CITY OF ALBUQUERQUE

**Re: Wise Recycling Center Amended Grading and Drainage Plan
Engineer's Stamp date 8-17-10 (M14/D032)**

**Re: Wise Recycling Center Grading and Drainage Plan
Engineer's Stamp dated 5-29-07 (M14/D032)**

Re. Wise Recycling Center Grading and Drainage Plan
Development and Building Services comments dated 4-23-07 (M14/D032)

WEST EDGE OF LOT DETAIL

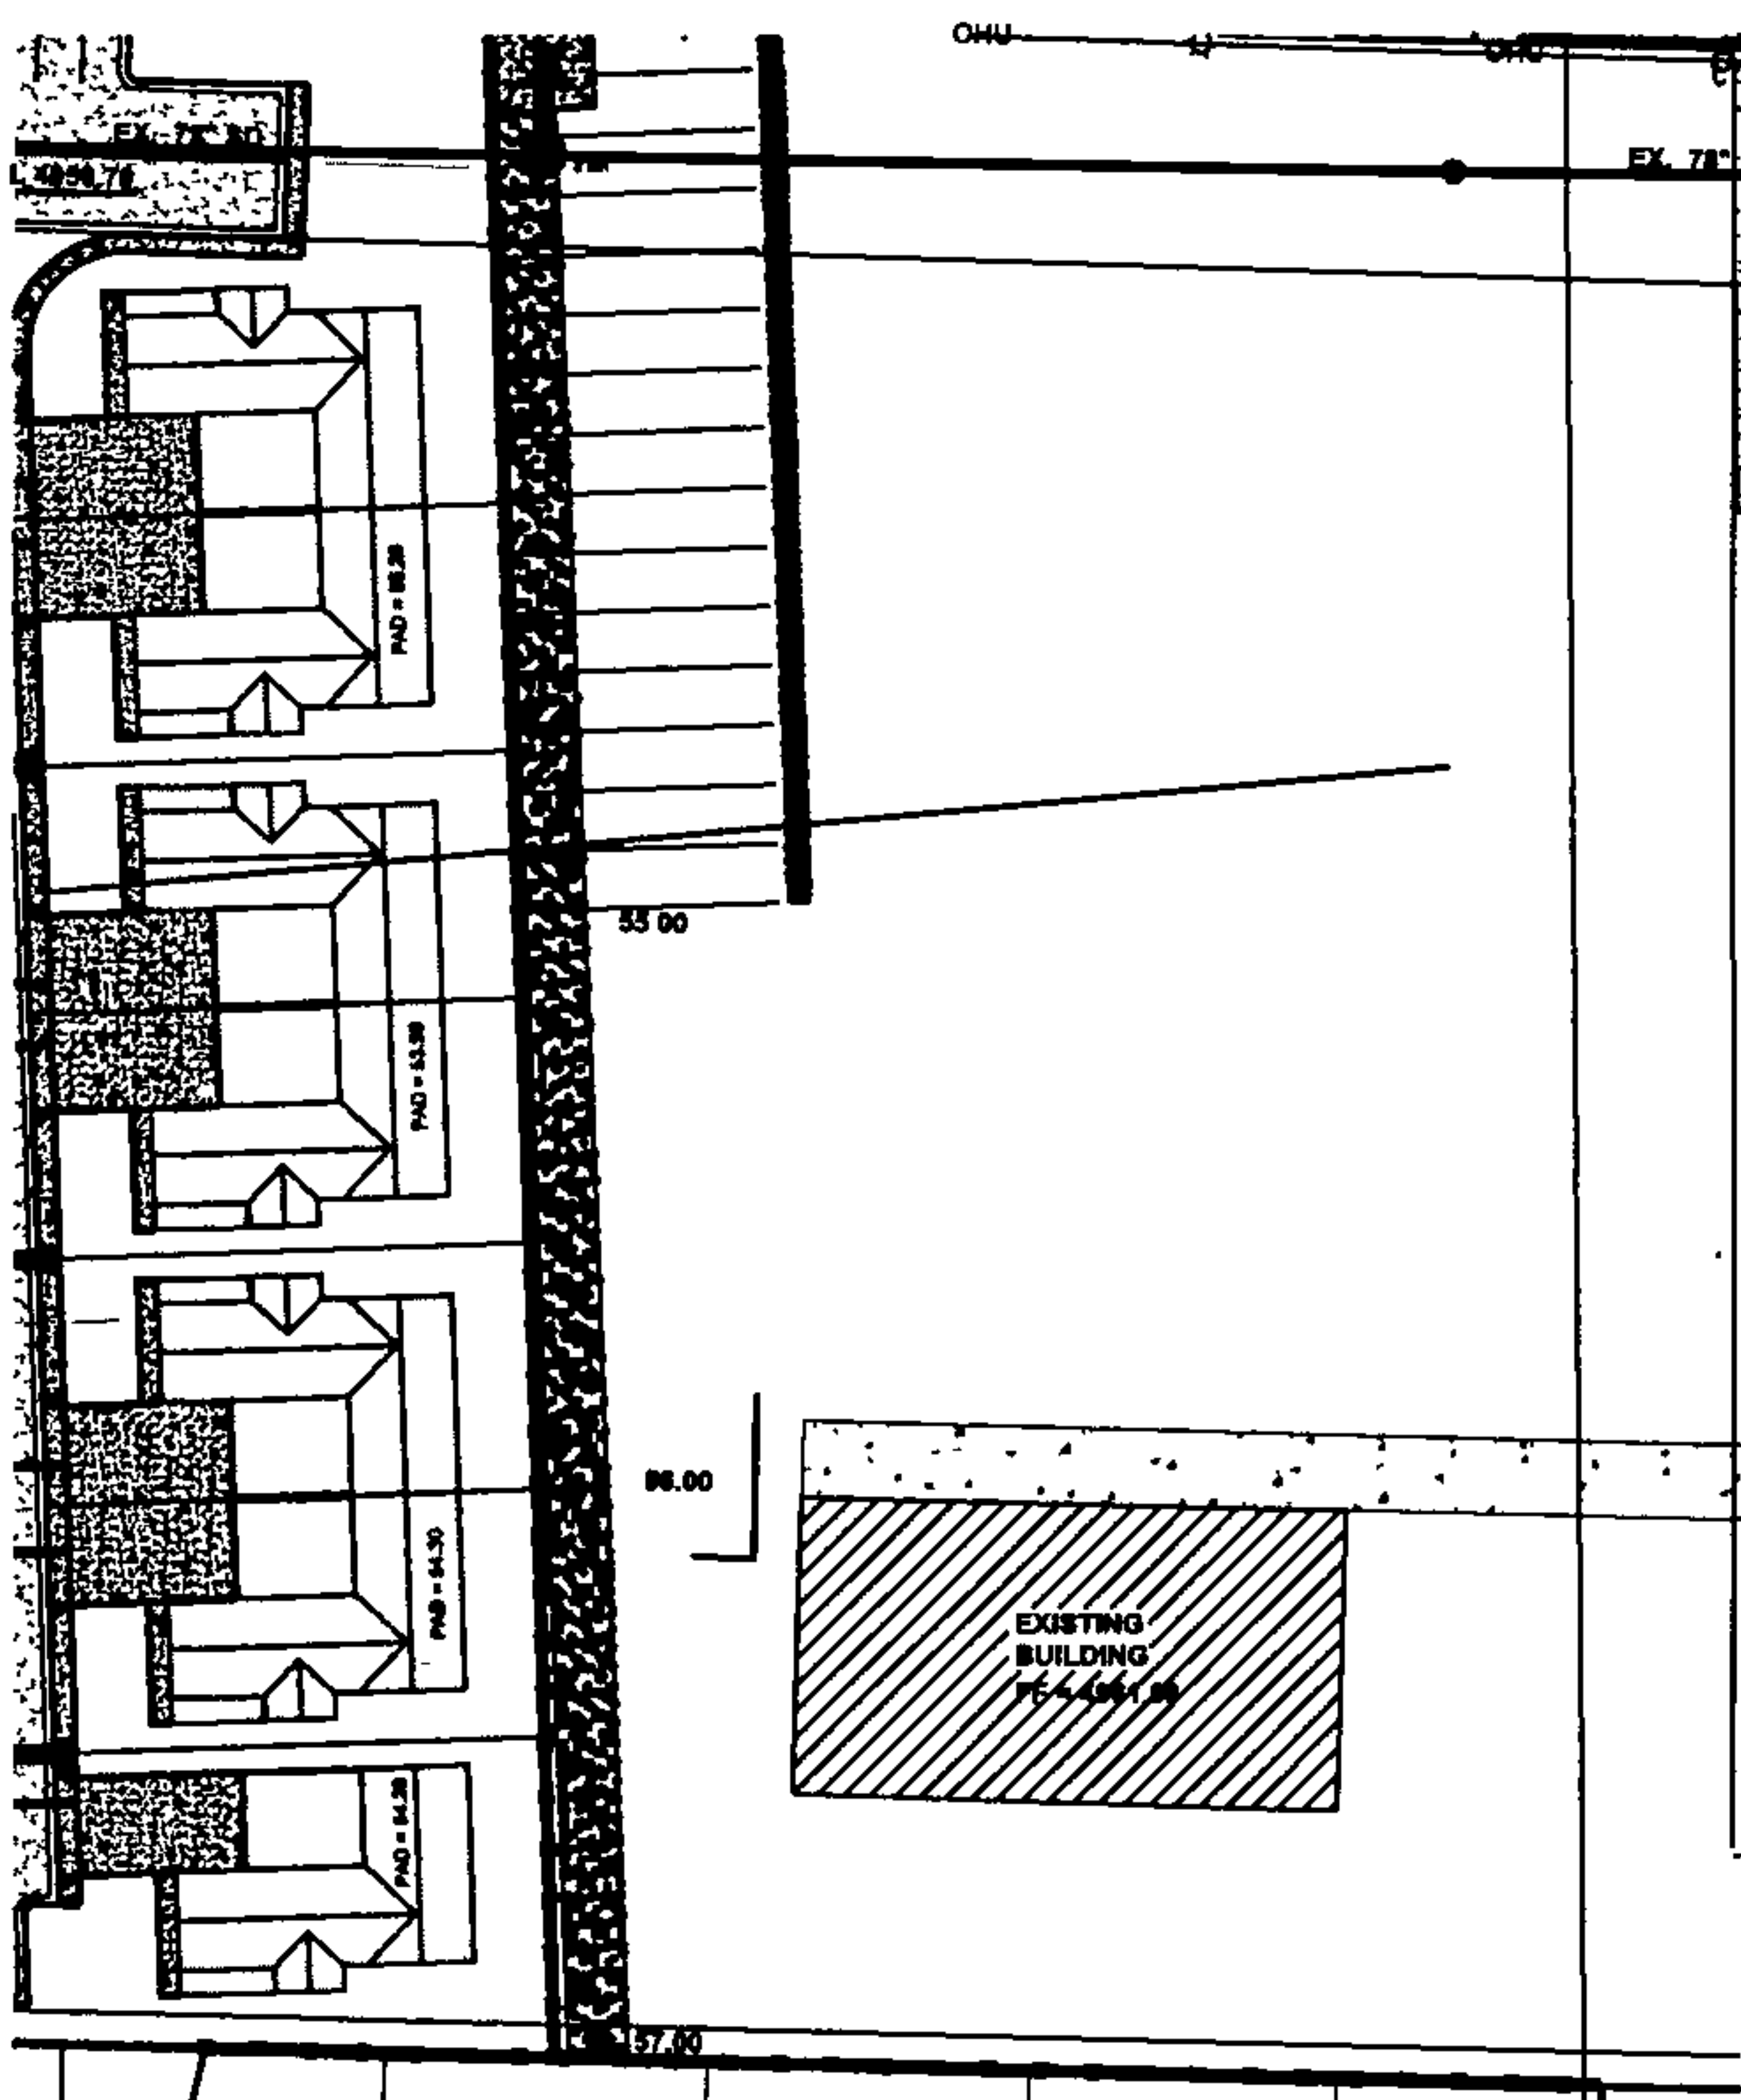
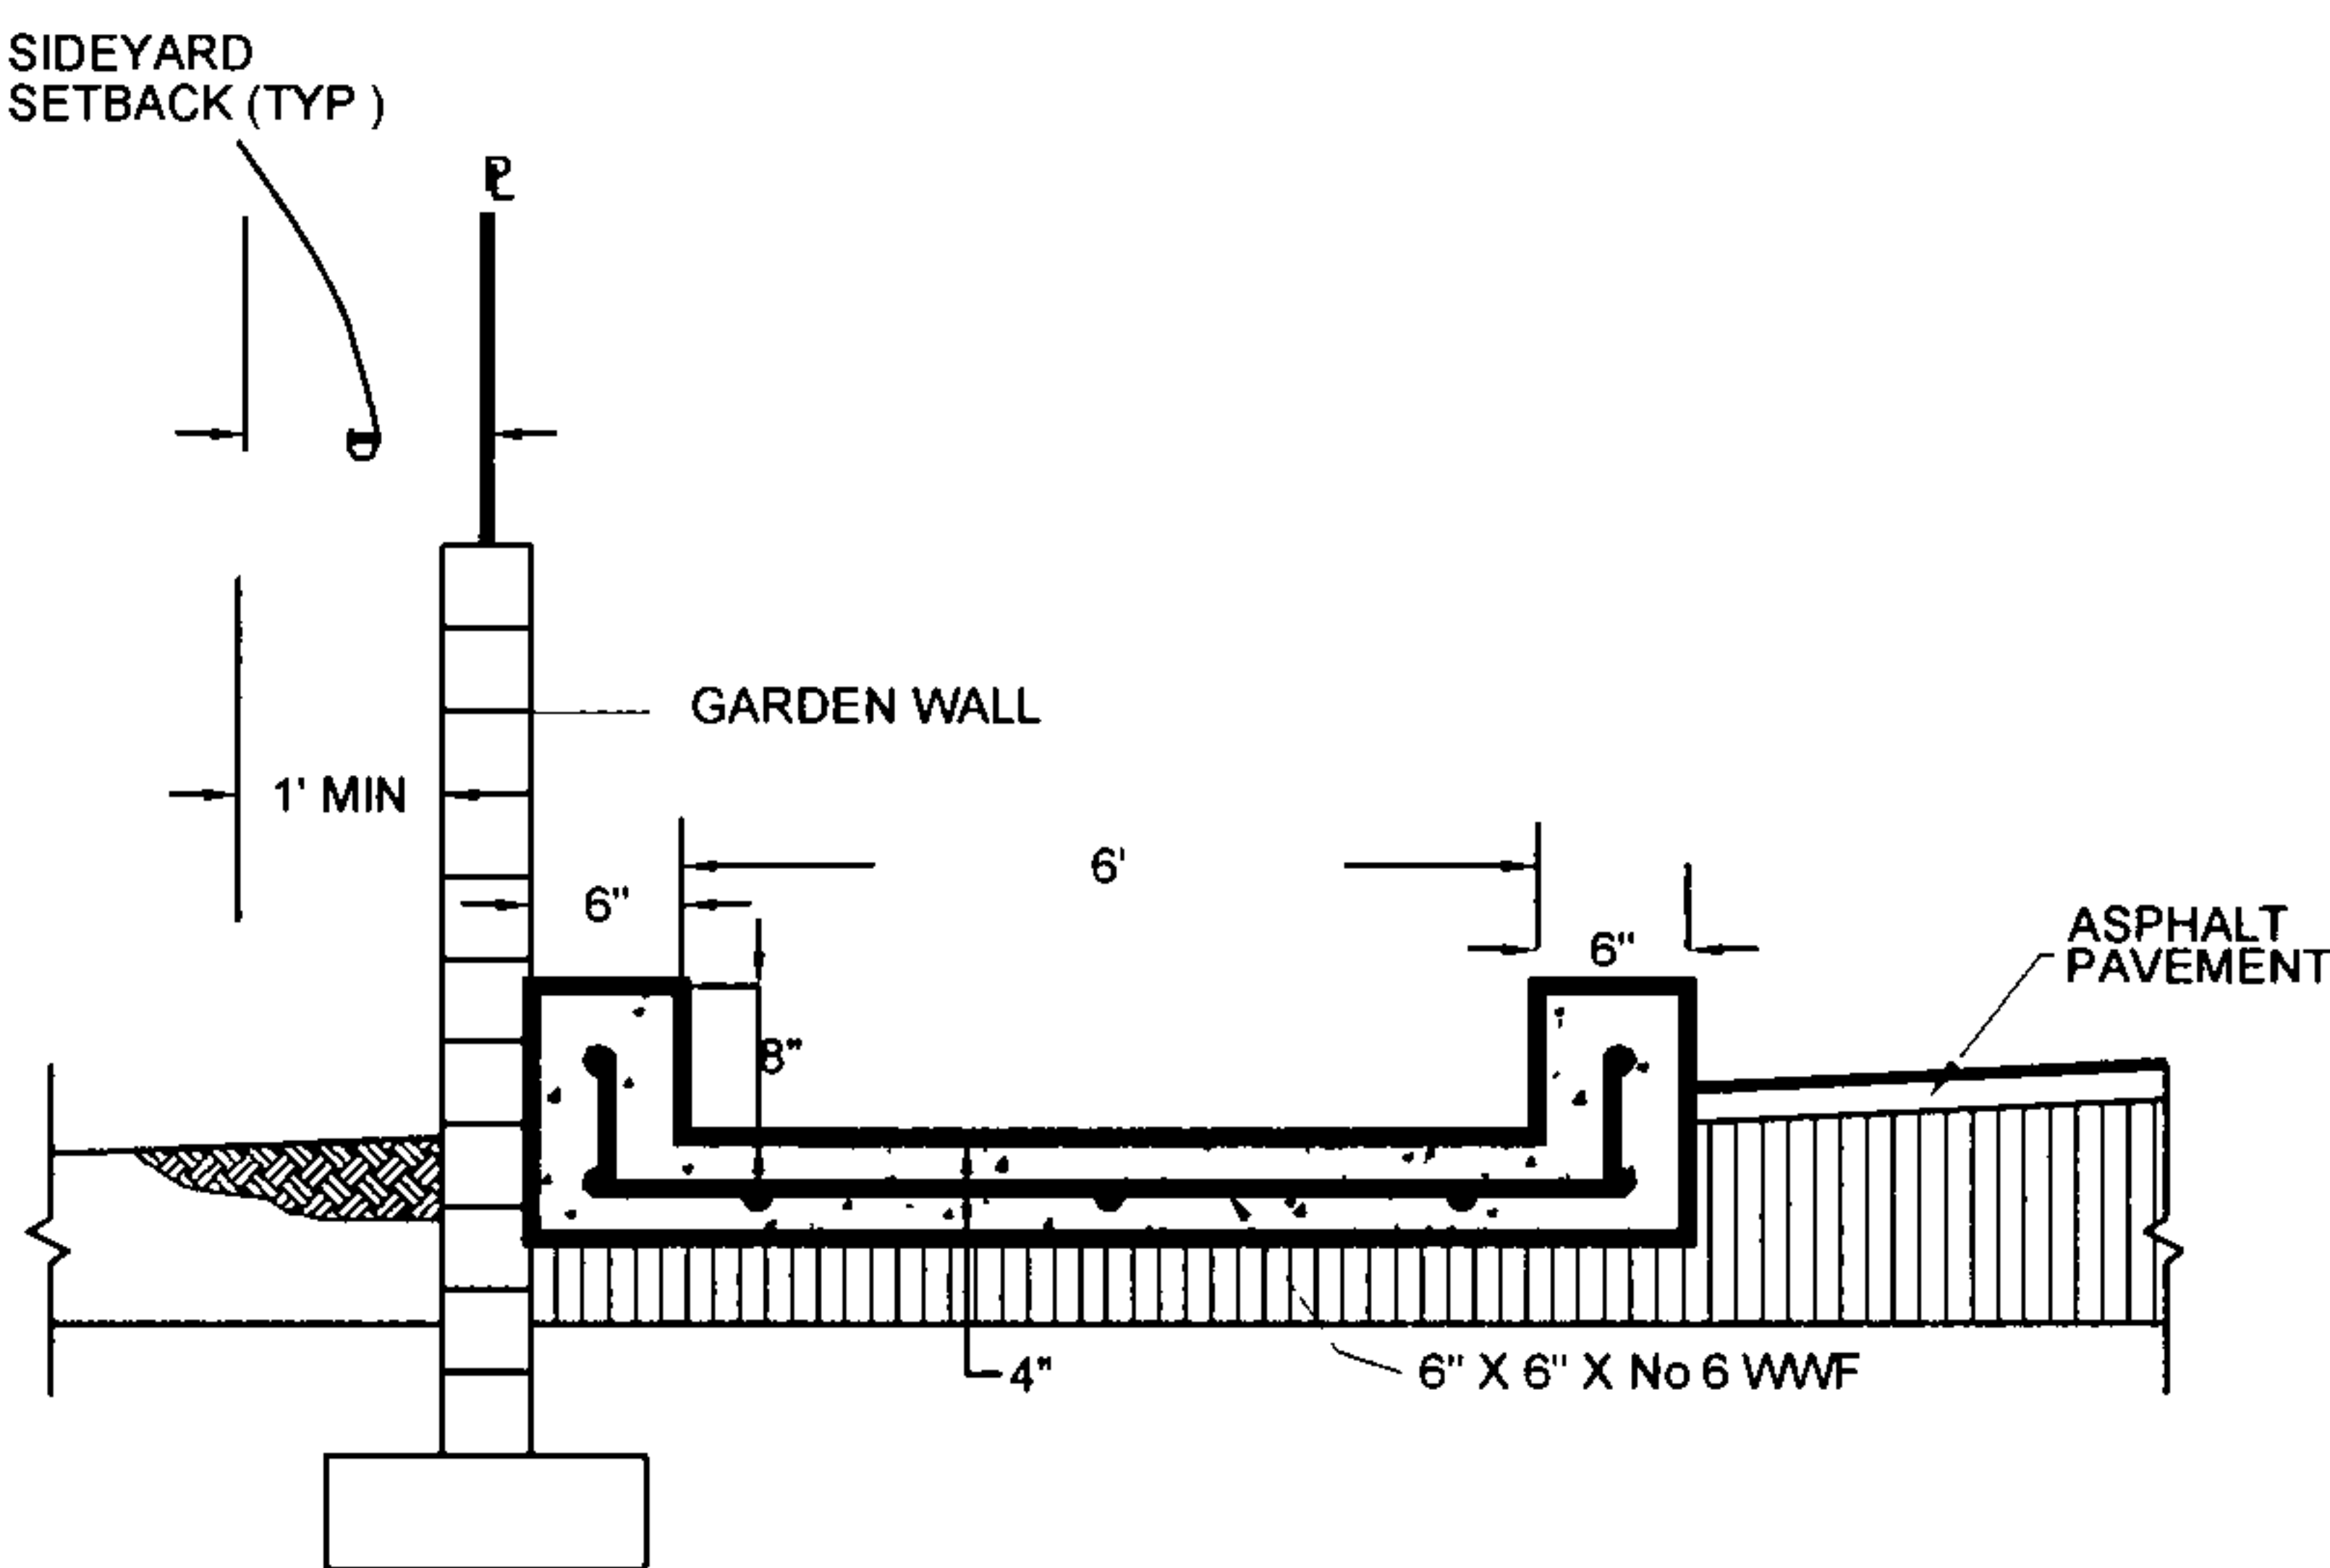
Q₁₀₀ = 20.7 cfs is less than Q = 21.6 cfs. good ~~except~~ *Q₁₀₀ = 24.5 cfs*
